HALTON CONSERVATION COMMENTS

Proposed Burlington Quarry Expansion Interim JART COMMENT SUMMARY TABLE – Hydrogeology

Please accept the following as interim feedback from the Burlington Quarry Joint Agency Review Team (JART). Fully addressing each comment below will help expedite the potential for resolutions of the consolidated JART objections and individual agency objections. **These interim comments will be finalized following the breakout meetings between JART and Nelson and any changes will be marked using “track changes”.** Additional, new comments may be provided once a response has been prepared to the comments raised below and additional information provided.

Figure 1: Simulated drawdowns in model Layer 6 due to (a) removal of the golf course irrigation ponds from the baseline conditions simulation and (b) removal of the infiltration feature from the P3456 conditions simulation.

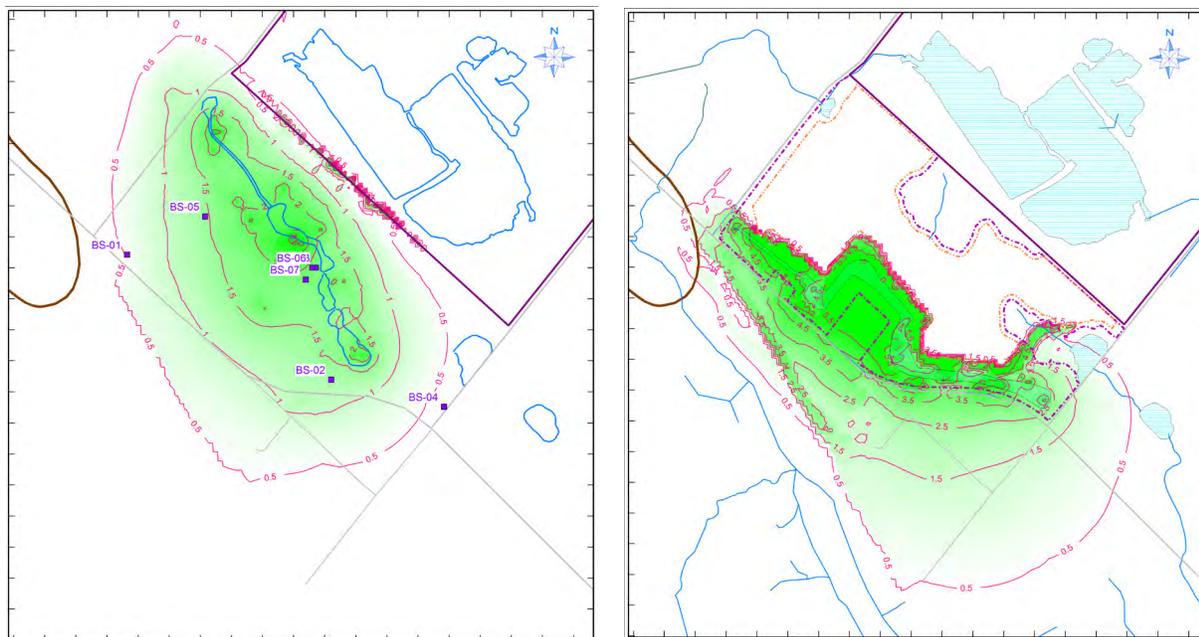
A similar analysis was conducted with the infiltration ponds removed from the P3456 conditions simulation. Drawdowns show that the feature contributes to an increase of 4.5 to 5.5 m beneath the ponds and about 1.5 to 4.5 m along Cedar Springs Road. Net seepage from the feature was estimated at 780 m³/d (about 120 igpm). It should be noted that the infiltration ponds were simulated in a very conservative manner, assuming that the feature could clog over time due to runoff from the surrounding area and accumulation of organic material. The total suspended solids in the quarry discharge are low and would not contribute to clogging. Clogging would be prevented by periodic maintenance of the feature.

Figure 2: Simulated streamflow in Willoughby Creek upstream of SW7 with (blue) and without (red) the infiltration feature.

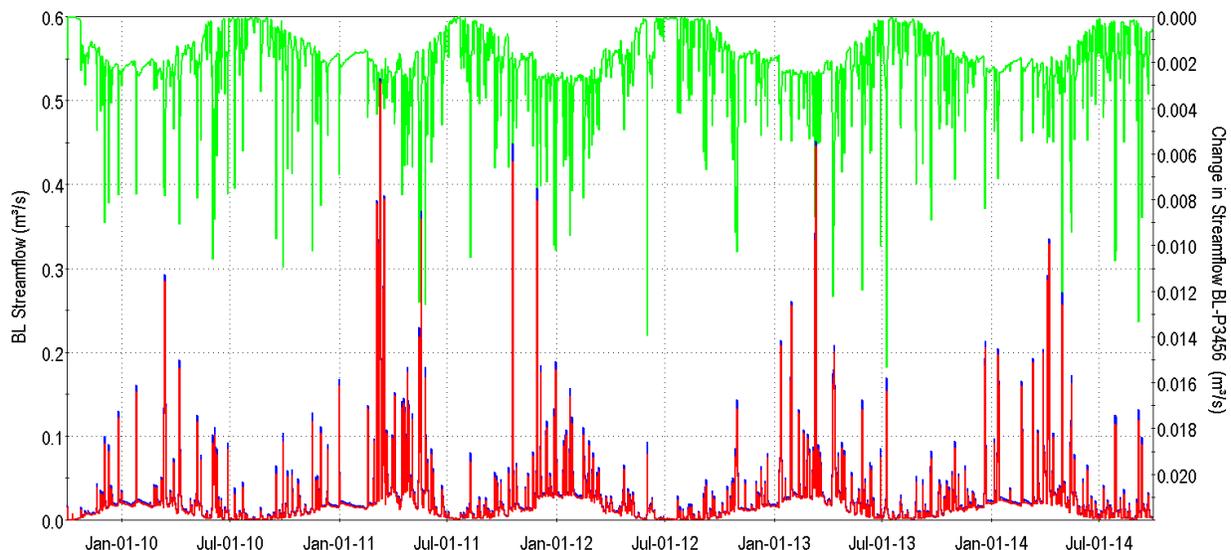
we are able to represent current groundwater levels and streamflow response very well and, therefore, the prediction of future response under quarry expansion is expected to have relatively low uncertainty.

Figure 3: Land surface elevation based on LIDAR data (no correction for tree cover).

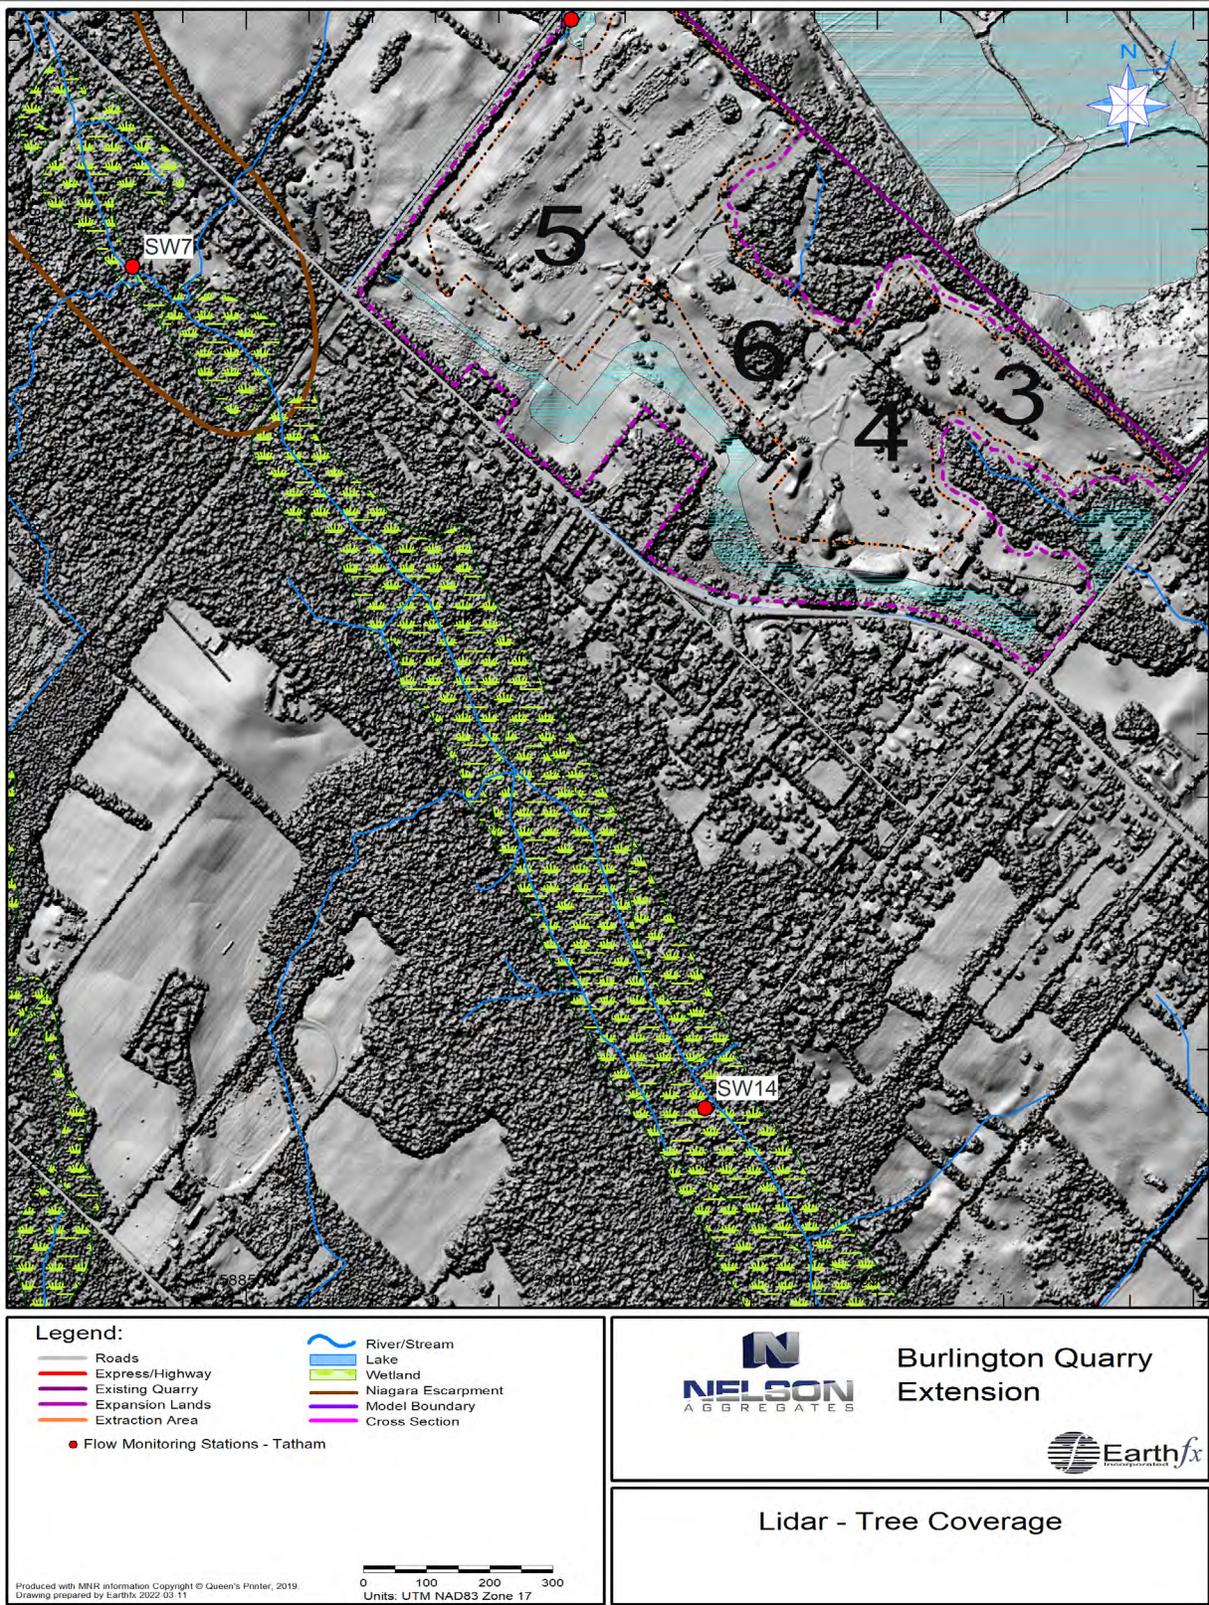
Figure 5, in particular, confirms that there are no discernible seeps and stream channels emanating from the east valley wall and joining Willoughby Creek.

Figure 4: Land surface elevation based on bare-earth LIDAR data

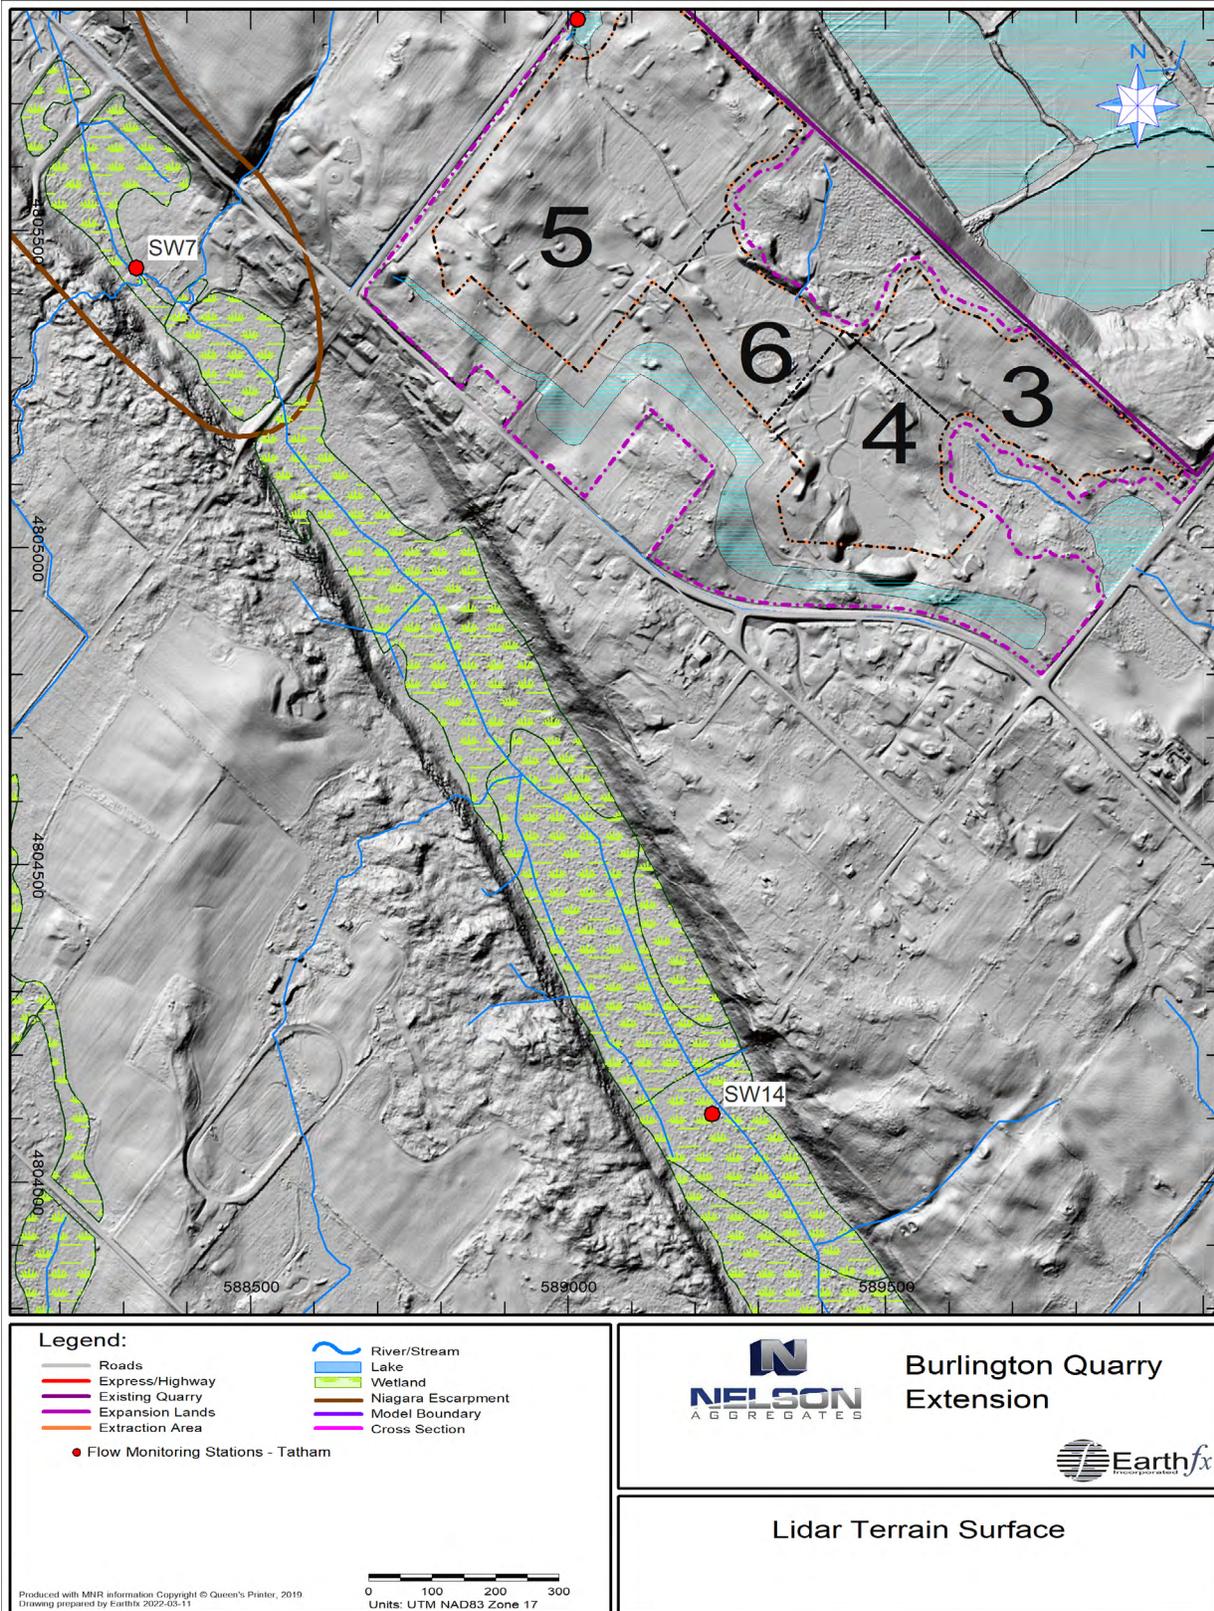
In summary, the LIDAR data shows that there is no incised stream channel within the broad, flat wetland that fills the valley. This is consistent with the water budget that shows that the majority of the groundwater discharge to the Medad Valley enters along the edge of the wetlands as distributed surface leakage. The model results are consistent with the new LIDAR data, and shows that the modest change in groundwater discharge will occur in a distributed manner along the eastern edge of the valley.

Figure 8: Temperature profile at well BS07 before, during and after the pumping test at BS-06 (From Earthfx, 2020, Page 439)

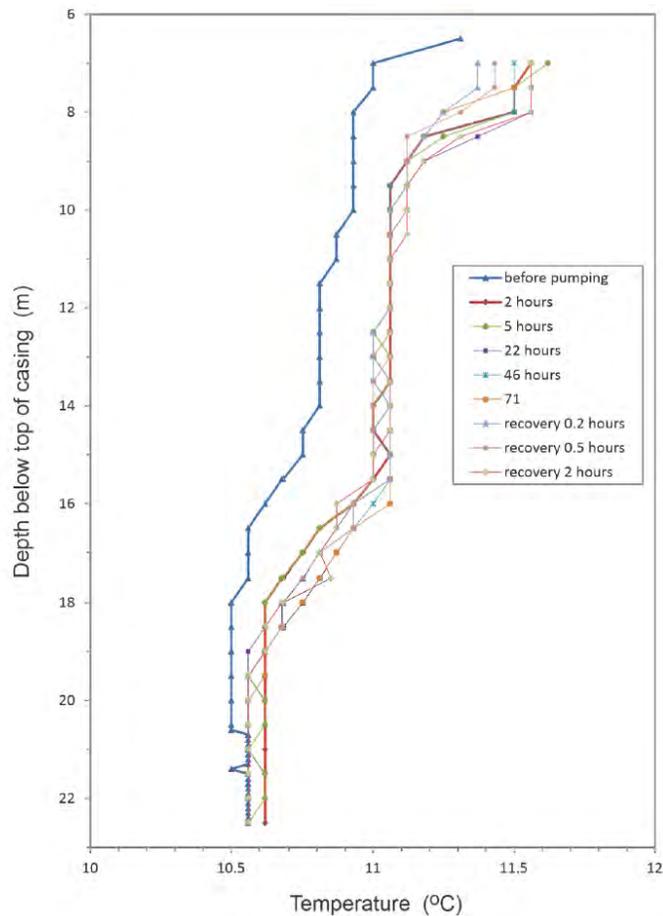
While there is natural variation in the rock properties in the area, there are no documented cases where there is insufficient available drawdown in the Amabel Aquifer (a widely recognized bedrock aquifer resource) for a private well supply. As discussed, natural variability is observed when comparing the higher response observed in BS-06 versus BS-07, however BS-07 would still be a suitable well for private water supply, even if it was not selected for the much higher capacity pumping test.

Figure 9: Location of water quality sampling points.

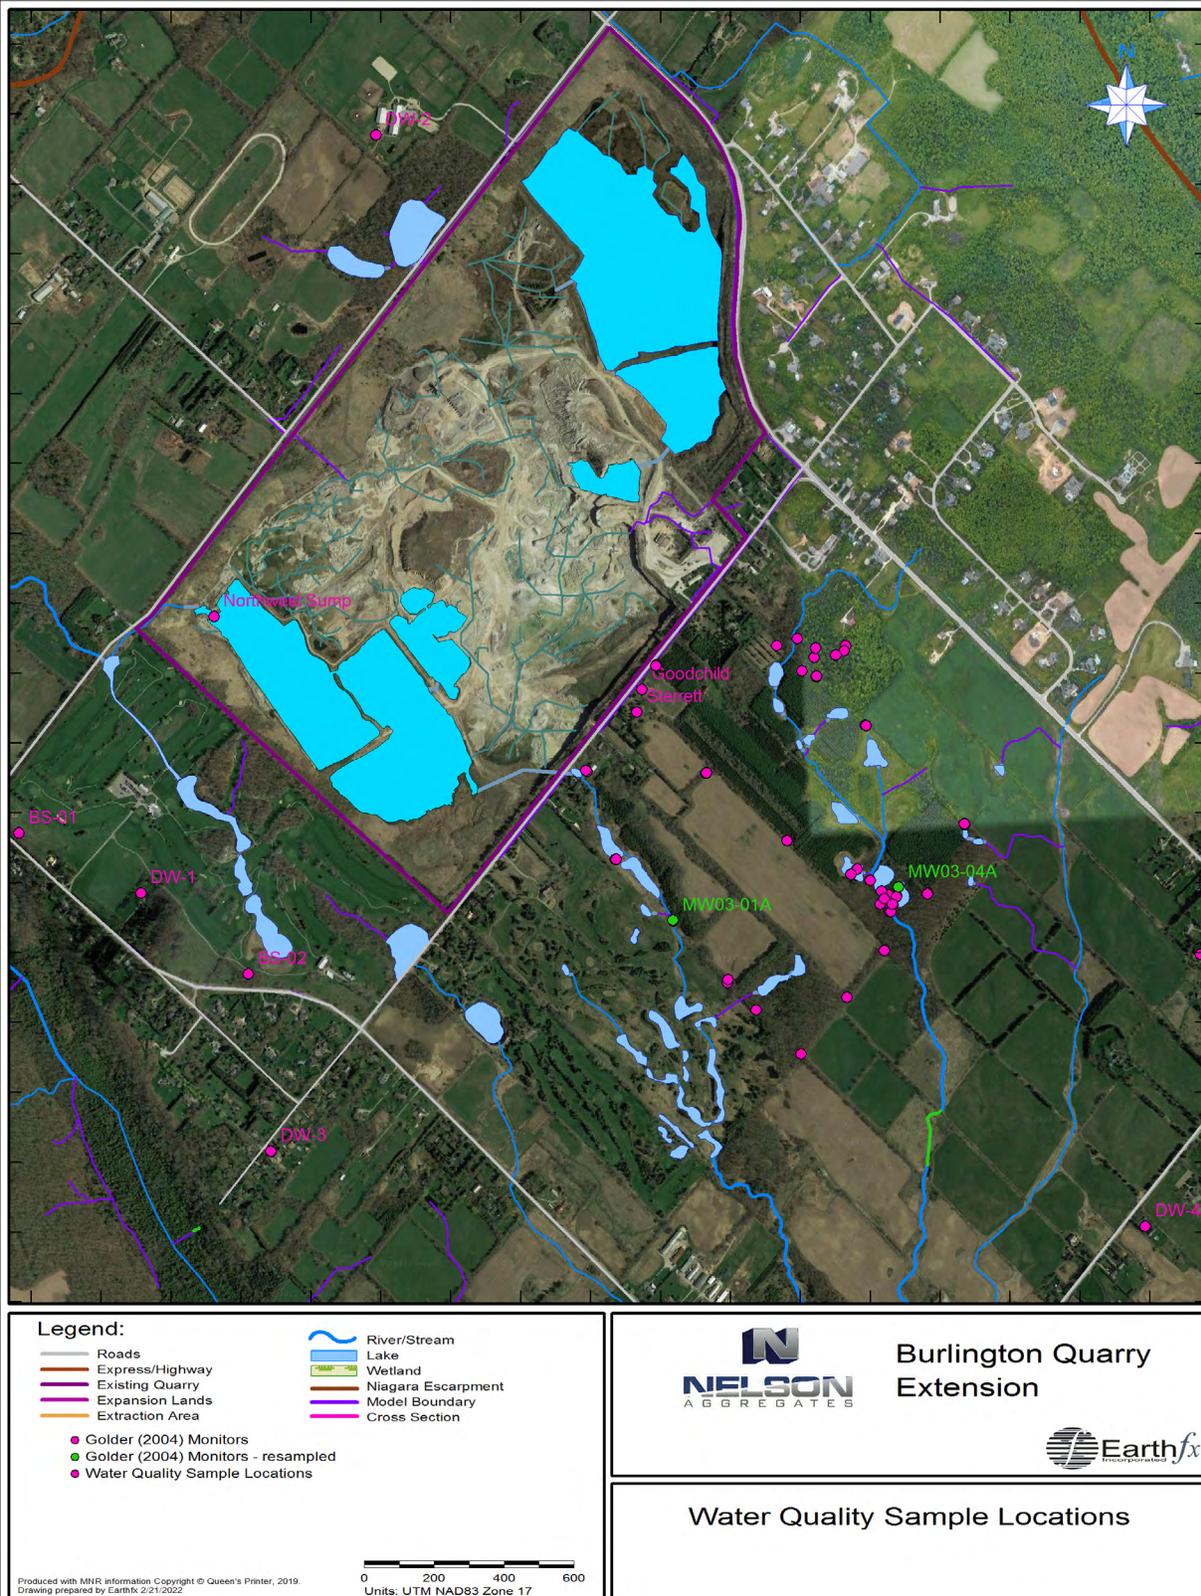
Background water quality in the west extension (without road salt impact) is better illustrated by the sampling at well DW1 (Figure 9). A number of domestic wells, the northwest quarry sump, and the golf course ponds were sampled in March and May of 2021 and analyzed for compliance with ODWO (Table 4). The samples for the sump and pond provide the most direct evidence that the quarry discharge is compliant with ODWO and should not be a concern for future infiltration. The Aesthetic Objectives for hardness and TDS are exceeded by all samples, with the sump and pond having the lowest values (The lower values are reflective of the mixing of groundwater inflows with direct precipitation into the quarry). DW1, located west of the golf course ponds, shows no effect of the ponds and good water quality. (DW3, located east of the quarry, appears to have been impacted by road salt.)

Figure 1: Scenario P3456 and Deep Pond Scenario configurations.

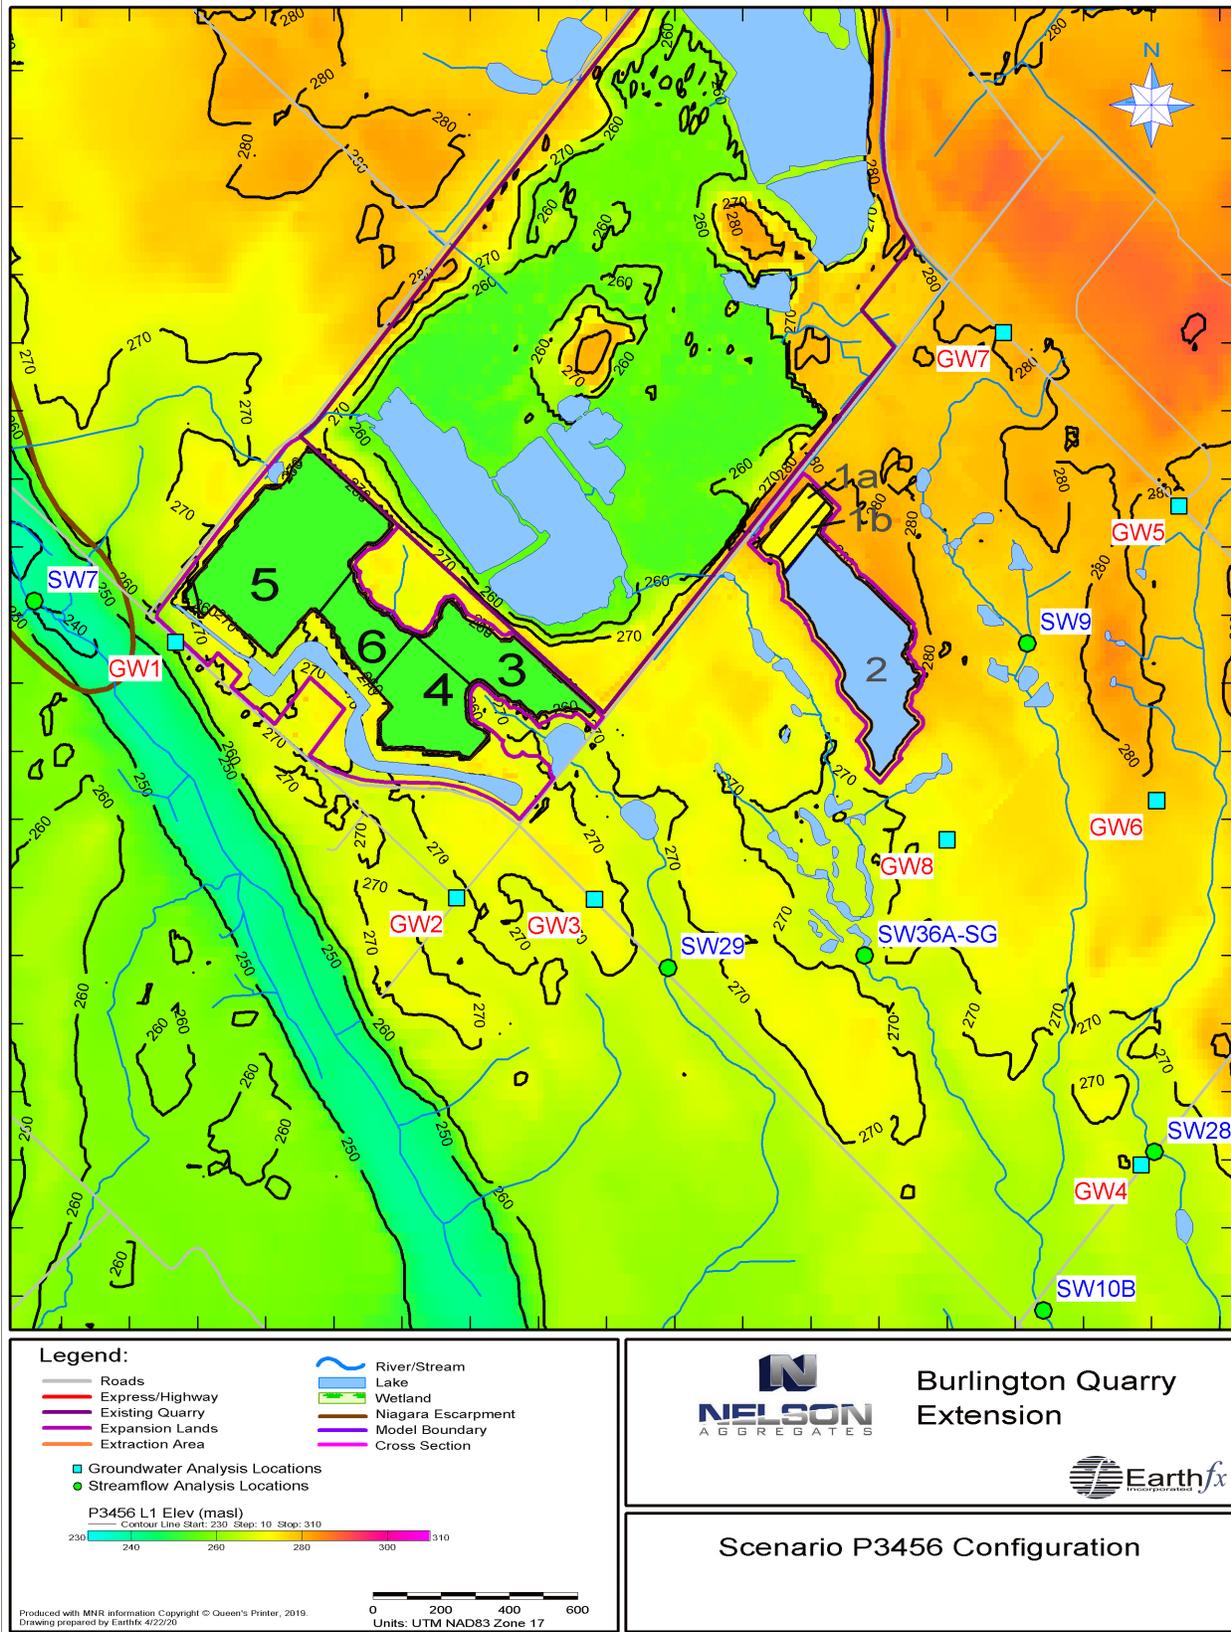
In summary, the original P3456 pond design is effective at generally replicating the effects of the golf course ponds. The effects of the design P3456, including the proposed shallow infiltration ponds, result in minimal impact on water levels in the Medad Valley.
